TECHNICAL SERVICE BULLETIN

Product: VIPER FCB

Subject: MOTOR BOARD ERRORS ("Motor Stall," "No Motor," or "MTR Comm Error")

Date: AUGUST 6, 2013

X-Ray view of improper pin alignment

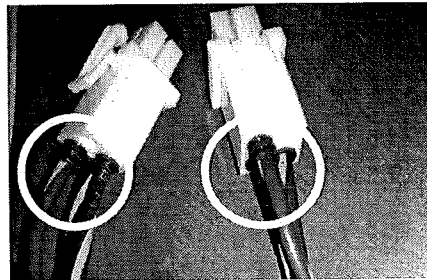
The motor board wiring harnesses may not be making an adequate connection due to pins that have backed out of the wiring harness housing or pins that are not centered correctly within the wiring harness housing. With this inadequate connection Viper units can experience several errors that are shown on the user interface as "No Motor," "Motor Stall," or "MTR Comm Err."

All Viper units manufactured after April 29, 2013, with serial numbers after **62C1322VP005** (22nd week of 2013) have had new wiring installed for each motor and motor board. If you have a Viper that was manufactured before the above date and before the above mentioned serial number, that is experiencing a large number of "No Motor", "Motor Stall", or "MTR Comm Err", individual wiring is now available for each motor. Please note the different part numbers for each motor, as each motor should have a different identification on the wire to aid in troubleshooting once the new wiring is installed. New wiring part numbers are as follows:

Wire ID.

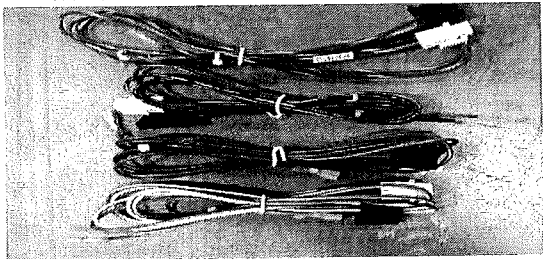
Bundle Harness will be replaced, with a single harnesses (see part numbers above).

Motor 1 with harness Part #: 620323348
Motor 2 with harness Part #: 620323706
Motor 3 with harness Part #: 620323717
Motor 4 with harness Part #: 620046535

Solid Color
White Line
Black Line
Grey Line

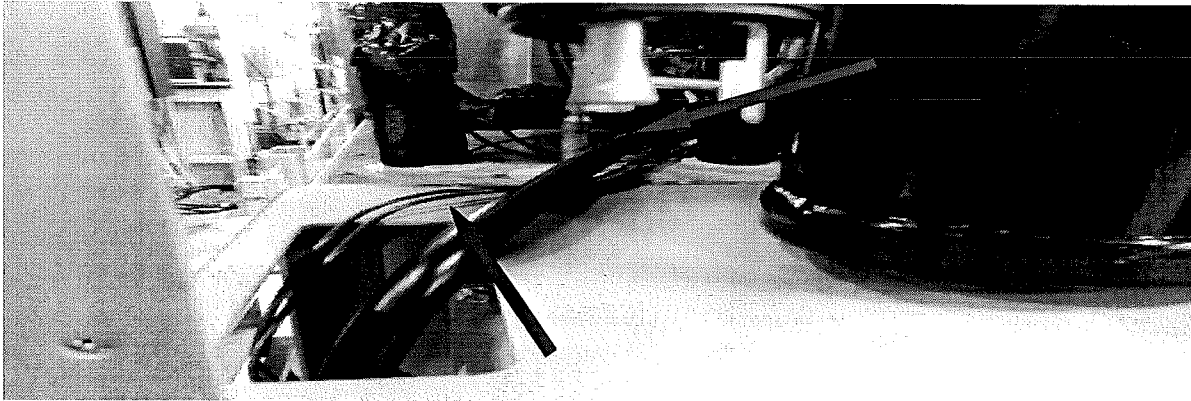
Repeat steps 2, 3 and 4 above for the motor harness number 3&4 (Plumb in the harness number 3&4 behind the filter copper tube to the board. (See picture)).

Expander board is attached to 3 and 4 motor units only. The plug in locations are marked with 1, 2, 3, or 4
